6 The Project

This section provides an updated description of the Project which reflects the changes made in response to submissions received during the public exhibition of the EA.

6.2 Changes since exhibition of EA

Figure 6-1: Changes to the turbine layout

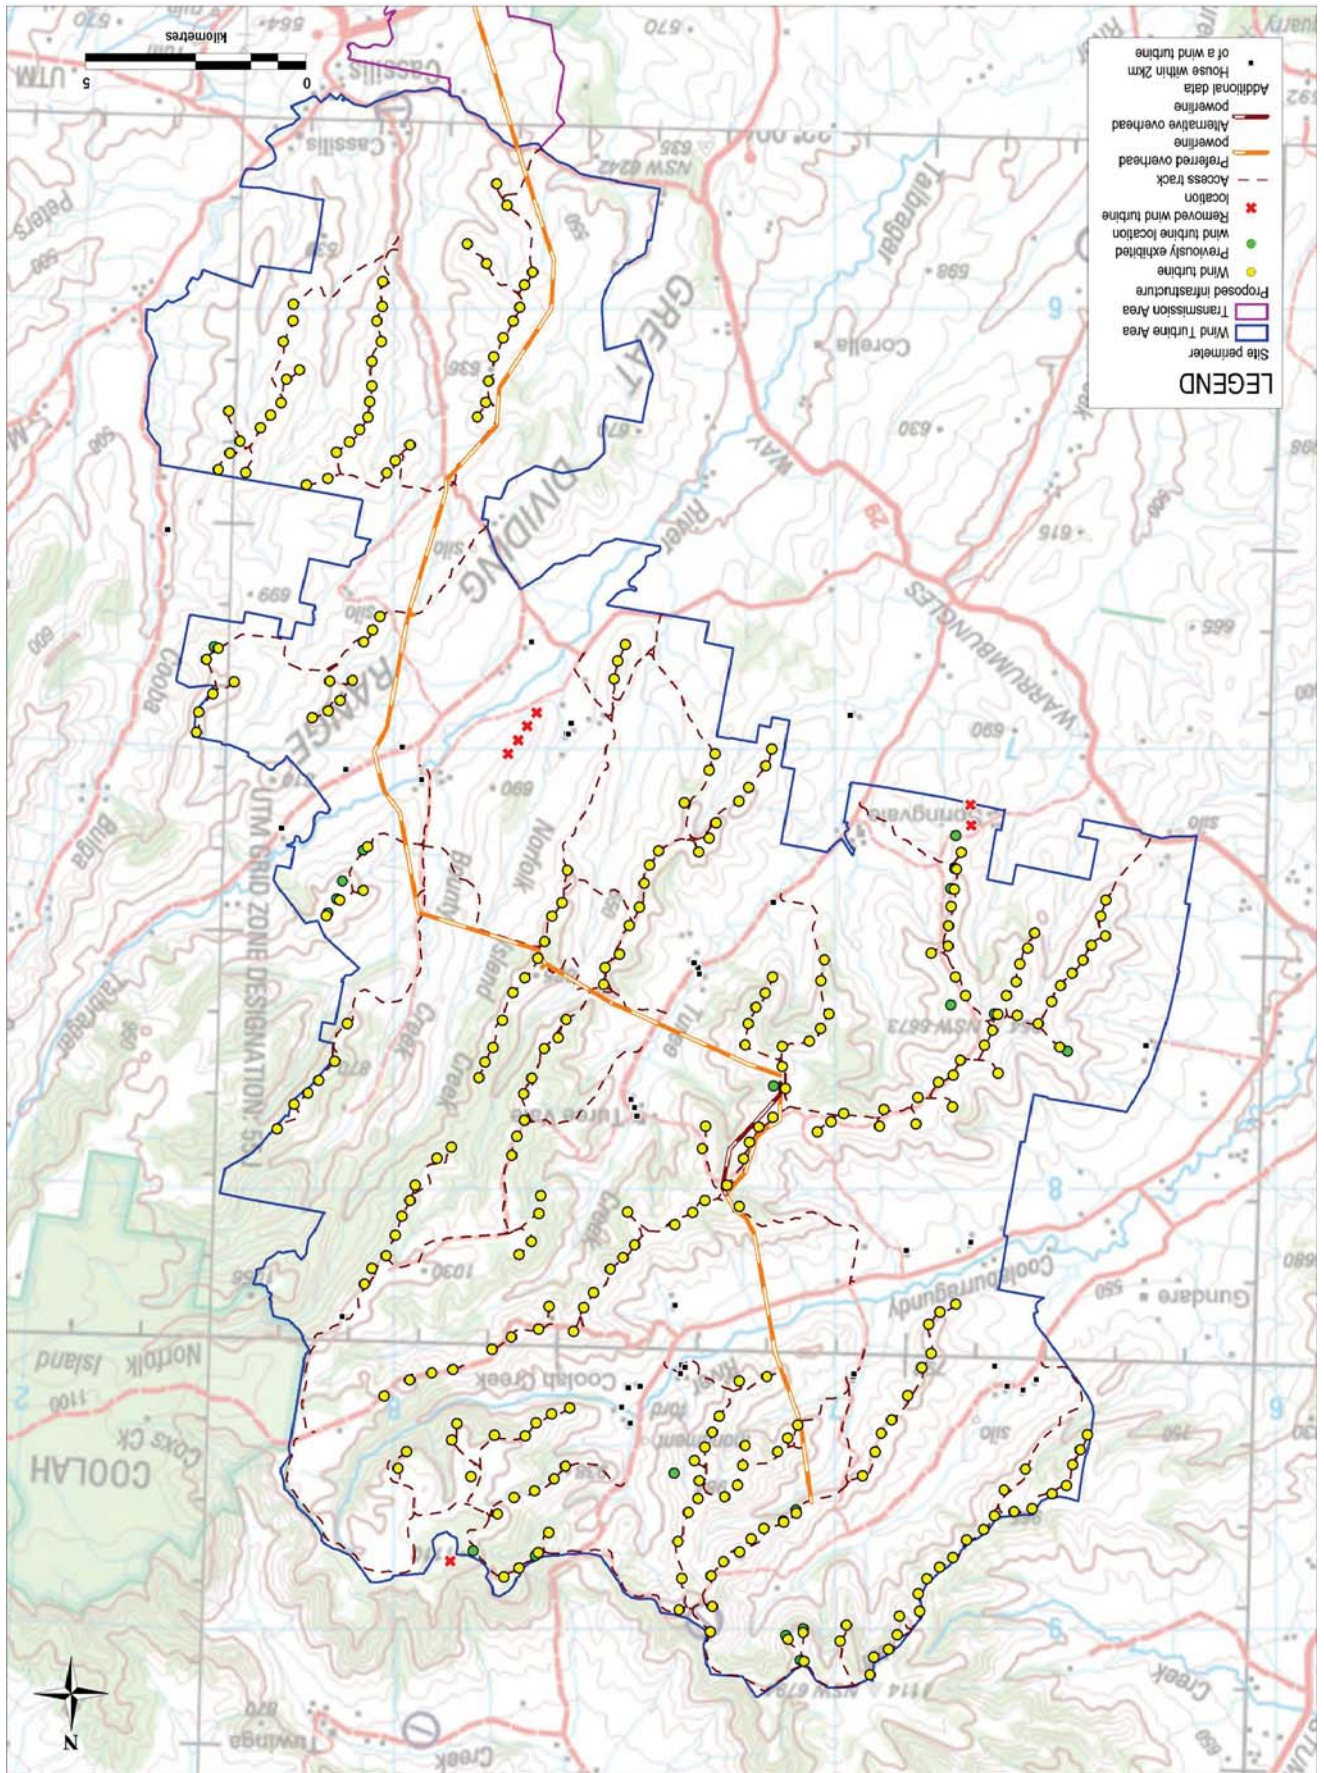
There have been a small number of changes to the turbine layout. Wind turbine locations were reviewed following the receipt of submissions from public and government stakeholders along with requests from landowners involved in the project. A total of 6 turbines have been removed from the proposal and 20 have been relocated for reasons described in Table 6-1. No additional turbines have been added to the project and the relocated turbines were all moved within the existing survey area, ensuring impacts were minimised within the known ecological values assessed. The changes have also been highlighted in Figure 6-1.

Table 6-1 Changes to the turbine layout

Turbine No.	Distance relocated (m)	Bearing relocated	Reason for move
2	398	SW	Avoid native vegetation
14	43	NW	Inter-turbine spacing
16	277	W	Improve constructability, avoid native vegetation.
53	80	W	Inter-turbine spacing
69	Deleted		Landowner request to avoid existing airstrip.
77	3218	N	Landowner request to avoid existing airstrip.
78	80	N	Improve constructability, avoid native vegetation.
83	95	NW	Inter-turbine spacing, avoid native vegetation.
90	72	W	Improve constructability
92	Deleted		Landowner request to avoid existing airstrip.
102	199	SE	Improve constructability
117	69	N	Avoid native vegetation
118	29	N	Avoid native vegetation
119	585	W	Reduced Visual Impact for E3-3
120	86	NW	Inter-turbine spacing
155	2065	SW	Relocated the single turbine proposed within Liverpool Plains Shire Council.
168	65	W	Improve native vegetation separation.
179	Deleted		Avoid noise and shadow flicker impacts at residence F7-3

186	523	NW	Improve native vegetation separation. Reduce noise and visual impacts for neighbouring residents.
204	Deleted		Avoid noise and shadow flicker impacts at residence F7-3
214	68	NE	Avoid native vegetation.
216	Deleted		Avoid noise and shadow flicker impacts at residence F7-3
223	1946	SW	Avoid native vegetation.
224	123	SW	Improve constructability
228	Deleted		Avoid noise and shadow flicker impacts at residence F7-3
245	97	W	Avoid native vegetation.

Figure 6-3 Changes to the Powerline layout – Wind Farm Area

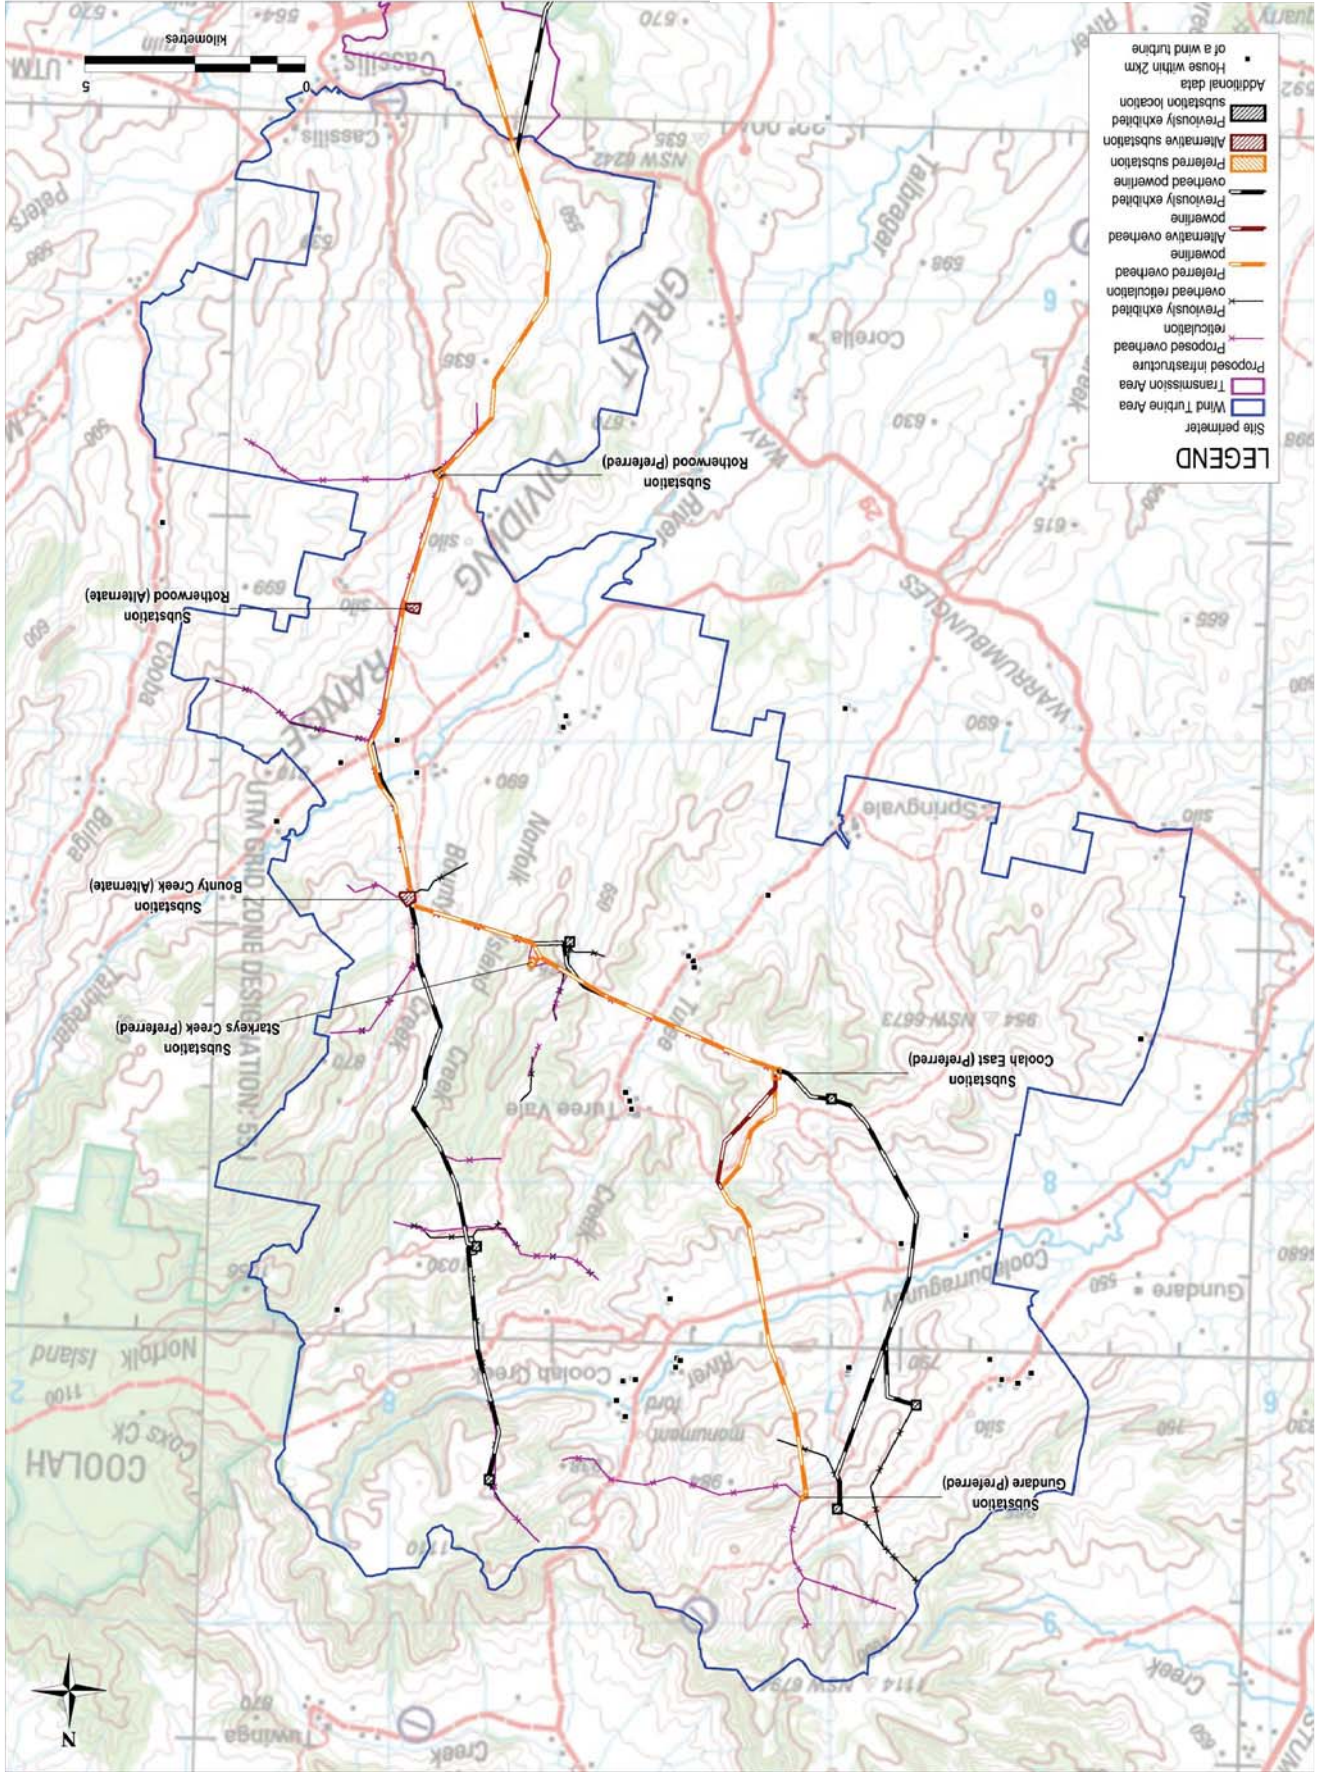
Two branches of the main powerline in the northern section of the site have been consolidated into one continuous line running from north to south. The overall number of substations on site and the temporary site facilities will remain the same, but their locations have been adjusted to accommodate the realignment of the main powerline. Likewise, the onsite overhead reticulation cabling has been adjusted to fit into the new design of one single powerline.

Table 6-2 Changes to the powerline layout

Item No.	Comment
Changes within the wind farm site	
1	330kV line from proposed Substation - Coolah Tops to Substation - Bounty Creek (Alternate) removed as part of the simplification of the main powerline and to minimise visual impact across the site.
2	330kV line moved between 1-3.5km east to connect the relocated Gundare and Coolah East Substations
Changes to the Transmission Line from wind farm site to connection substation at Ulan	
3	330kV line relocated north-west through Durridgerie SCA to reduce ecological impacts. The route then continues west to cross Ulan road near Cliffdale Road.
4	330kV line relocated to western side of Ulan road between Cliffdale Rd and Durridgerie Rd.
5	330kV line realigned to avoid Square Tail Kite nest (approximately 4km north of connection substation)

The EA presented six collection substations on the wind farm site with several alternate options. As part of design development and as a result of simplifying the main powerline, the number of proposed substations has been reduced to four preferred locations with two alternate locations. Figure 6-3 shows how the main powerline simplification has enabled the reduction in substations and the new locations compared to those exhibited in the EA.

Table 6-3 Changes to the O&M facility, substation, concrete batch plant and other infrastructure layout

Item No.	Comment
1	Gundare Substation (Preferred) relocated 785m East to accommodate simplification of the main powerline
2	Turee North Substation (Preferred) removed - redundant substation option removed due to simplification of main powerline.
3	Coolah Tops Substation (Preferred) removed - redundant substation option removed due to simplification of main powerline.
4	Coolah East Substation (Preferred) relocated 1,360m South East to accommodate simplification of the main powerline
5	Gundare Substation (Alternative) removed - redundant substation option removed due to simplification of main powerline.
6	Starkeys Creek Substation (Alternate) relocated 960m North East and reclassified as Starkeys Creek (Preferred) as part of design development resulting from the simplification of the main powerline.
7	Bounty Creek Substation (Preferred) reclassified as Bounty Creek Substation (Alternative) as part of design development resulting from the simplification of the main powerline.

Figure 6-4: Changes to the Powerline layout - Transmission Area

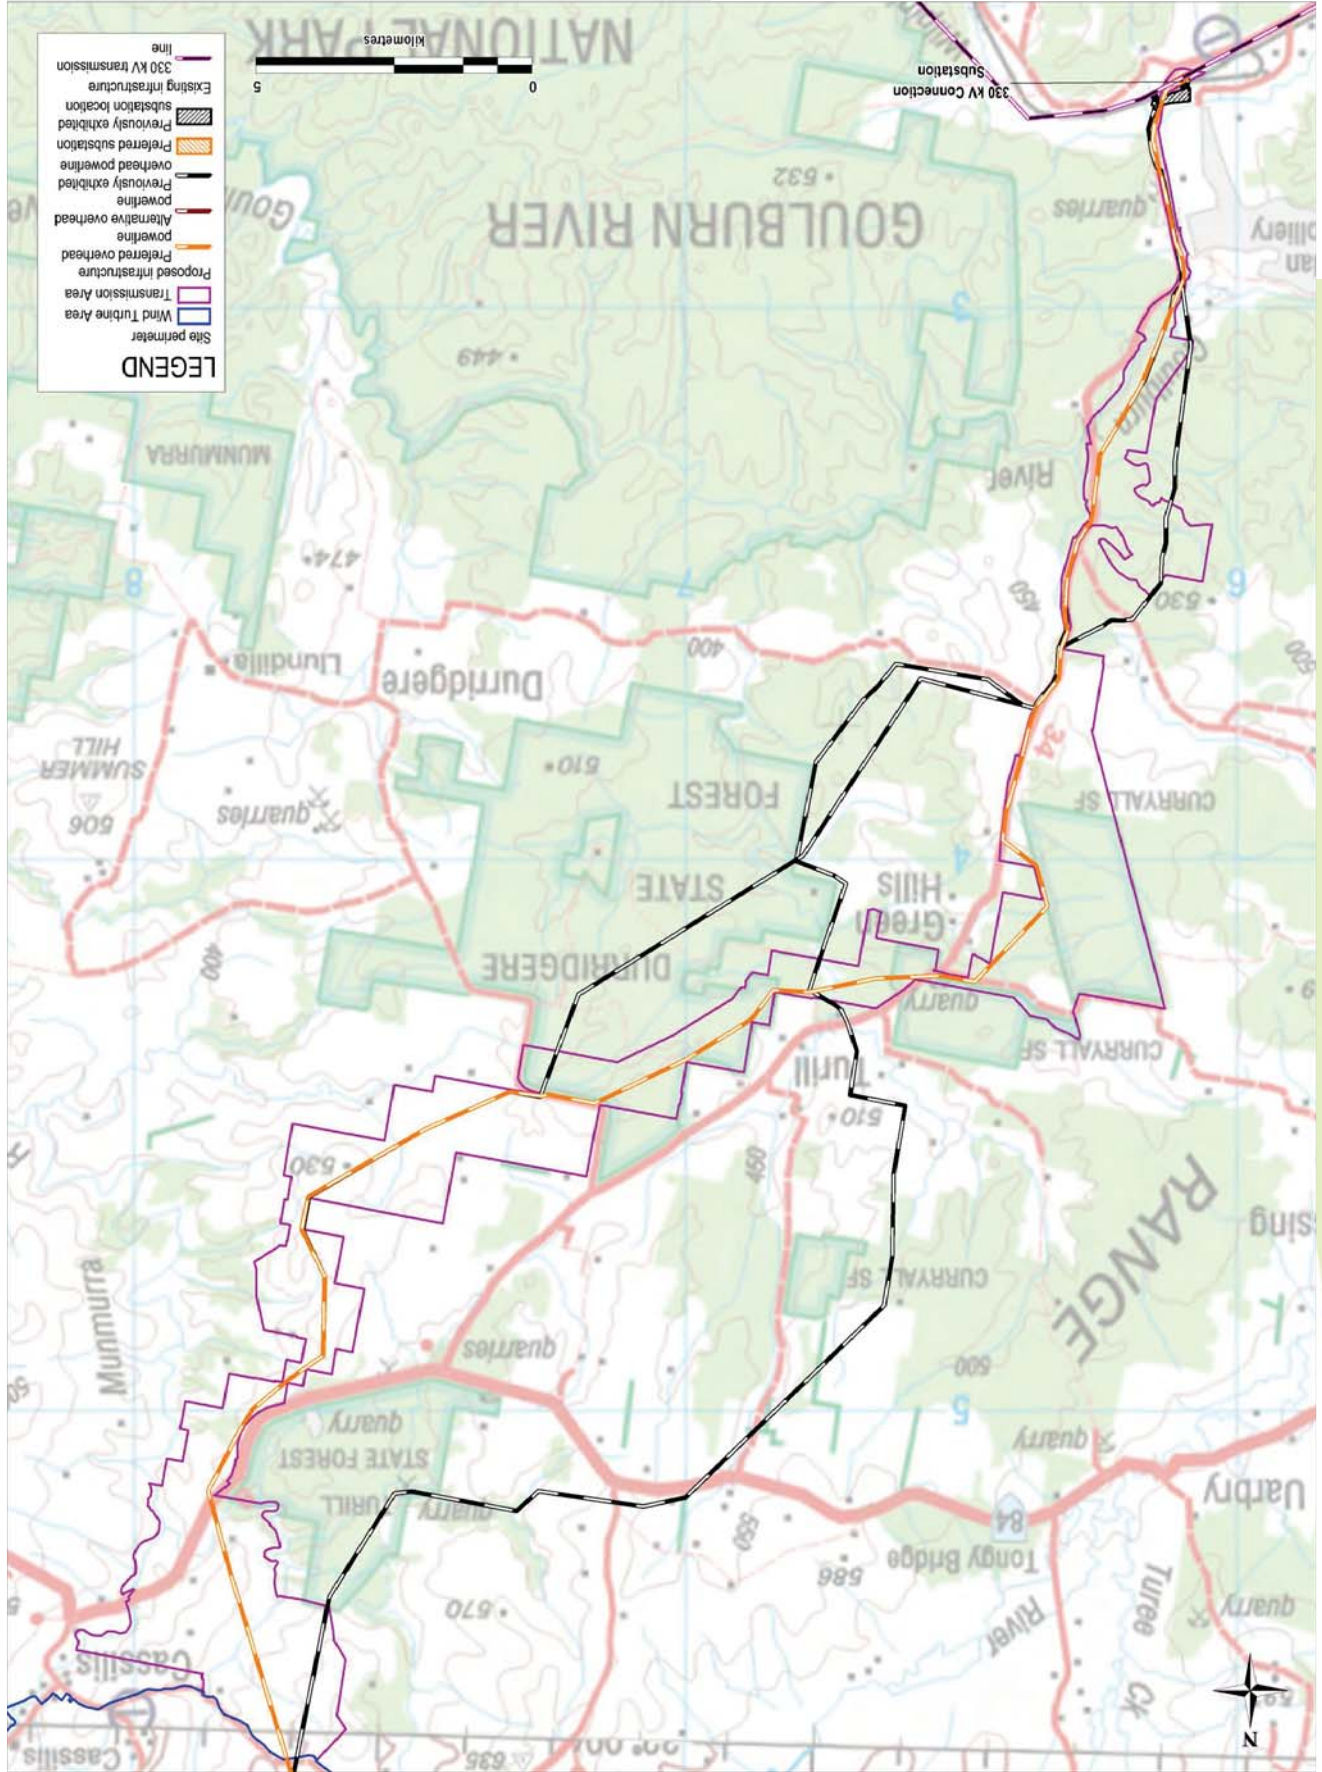
The most noticeable change to the proposal is the alignment of the main powerline running from the southern boundary of the site down to the connection substation at Ulan. While a preferred and alternate route was submitted as part of the EA, this has largely been consolidated into a single route.

Figure 6-5: Example of changes to the powerline route

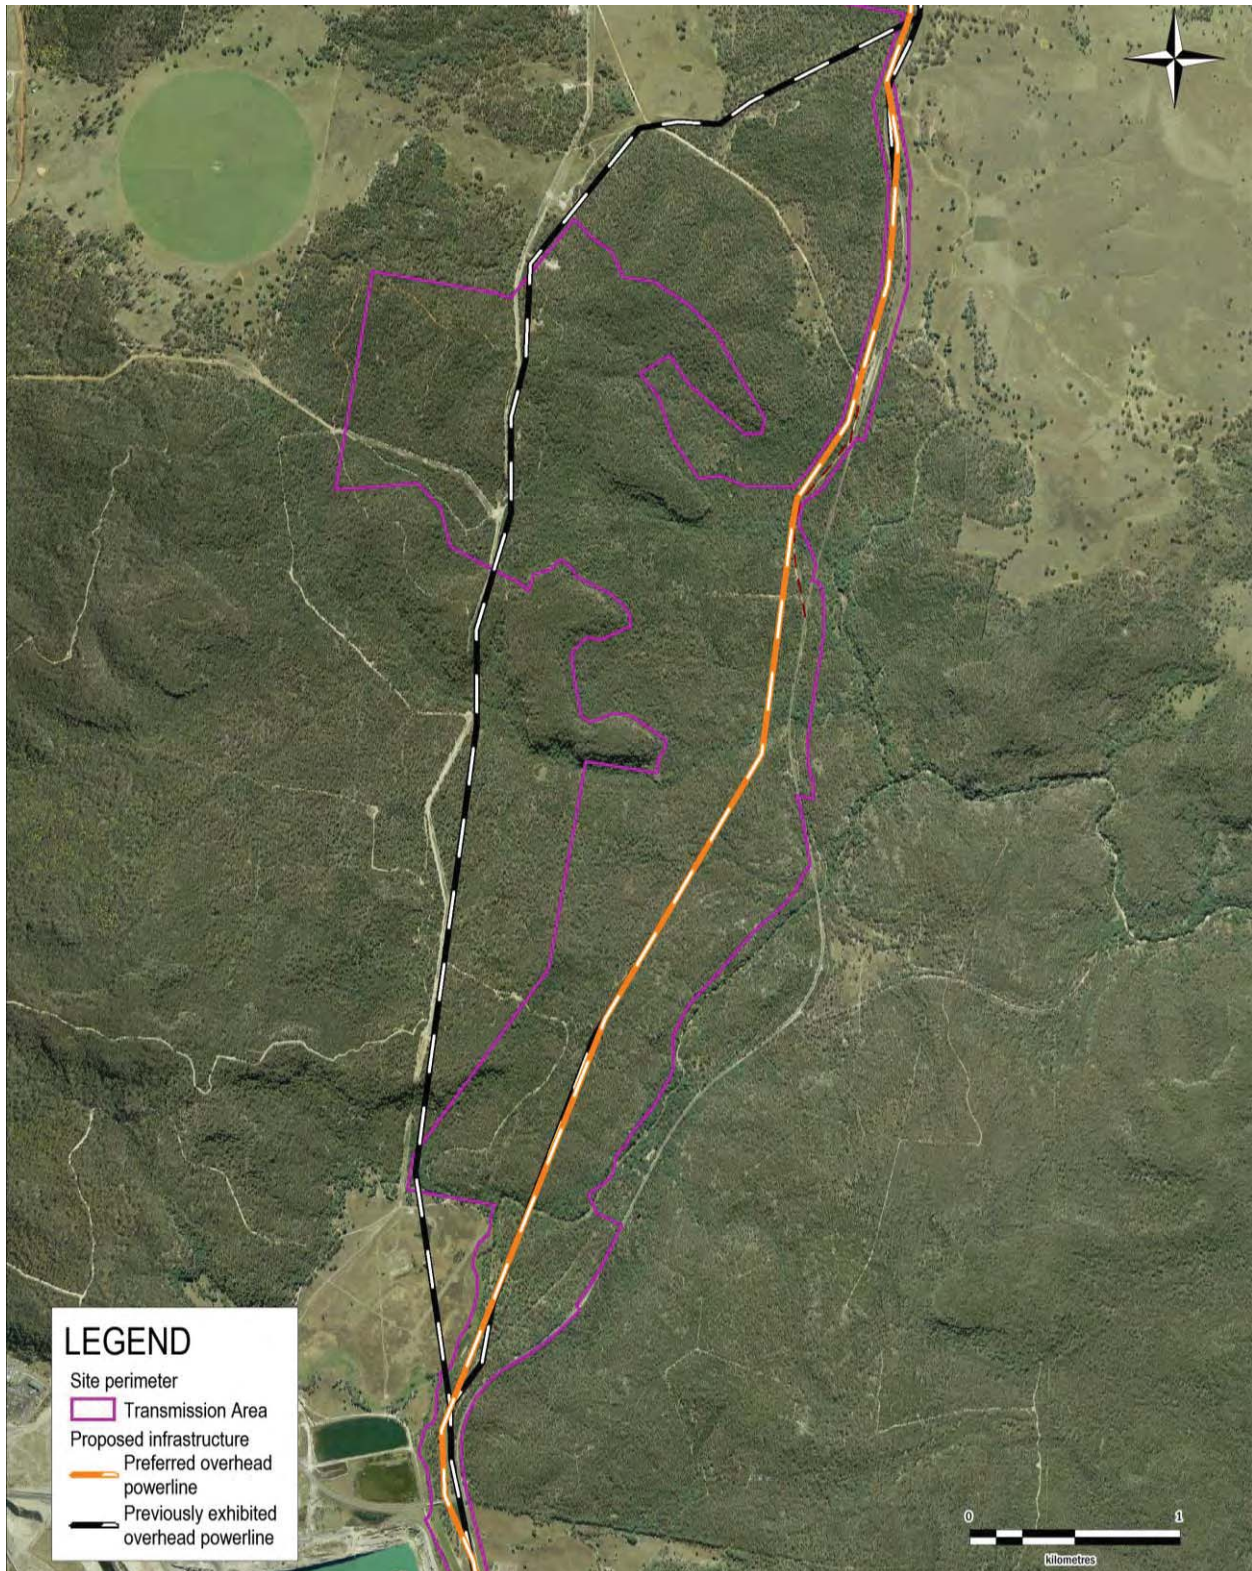
The net result of these changes means an overall reduction in the footprint required, in turn reducing the impact area for vegetation clearing. Some micro-siting of the main powerline has also occurred to ensure that the easement avoids wooded areas wherever practical.
